Re: Four Seasons Plaza West (National City Bank ATM): An Amended Site Development Plan, Architectural Elevations, Lighting Plan and Architect's Statement of Design for a 2.35 acre tract of land zoned "PC" Planned Commercial District located on the southwest corner of the intersection of Olive Boulevard and River Valley Drive.

Project Name: Four Seasons Plaza West
(National City Bank, ATM)

FOUR SEASONS PLAZA WEST AMENDED SITE DEVELOPMENT PLAN

ATM DETAIL
SCALE 1"=5'

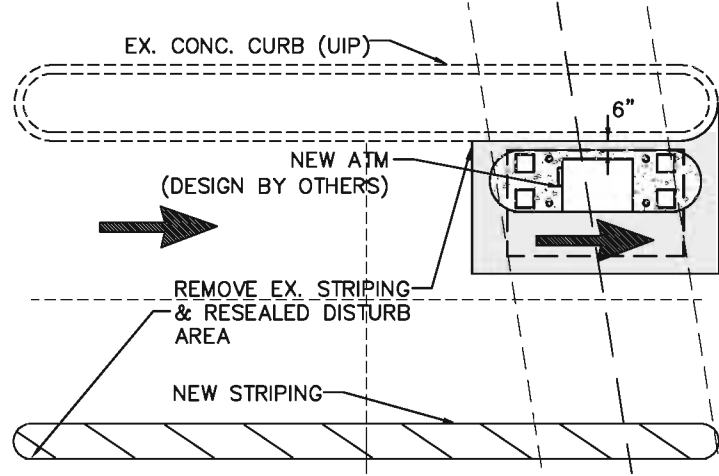
1. Recommendation that the island adjacent to the ATM be improved with some low level (30"-36") evergreen shrubbery to provide screening to the back of the ATM.

The petitioner has agreed to add landscaping to the adjacent island to provide screening for the back of the ATM. See the petitioner's letter attached in the Architectural Review Board Packet.

This is to verify that we will landscape the island directly next to the proposed ATM. It will be designed to provide screening at the lower level. We will submit a landscape plan to the City, for staff approval, prior to construction.
